DART SERVICE INSTRUCTION

TO AMEND INSTALLATION INSTRUCTIONS IIN-D427-659 Rev. A AND
INSTRUCTIONS FOR CONTINUED AIRWORTHINESS ICA-D427-659 REV. 0

REF FAA STC: SR01532NY

Figure 1 - Center ski trimming details

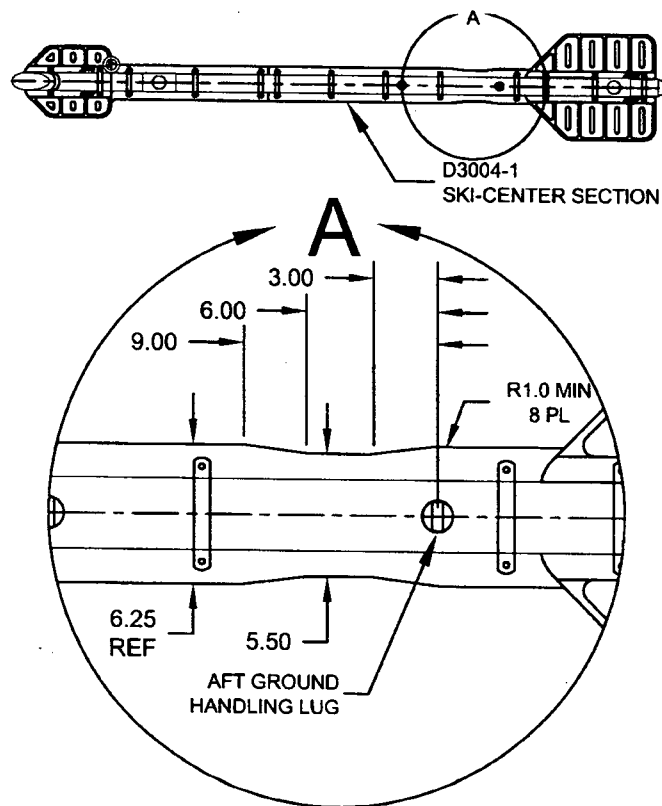
It has come to Dart's attention that interference between the Ground Handling Wheels and the D3004-1 Center Section Ski may exist when using OEM Ground Handling Wheels. It is acceptable to trim the D3004-1 Center Section Ski to remove the interference as shown in Figure 1 of this DART Service Instruction.
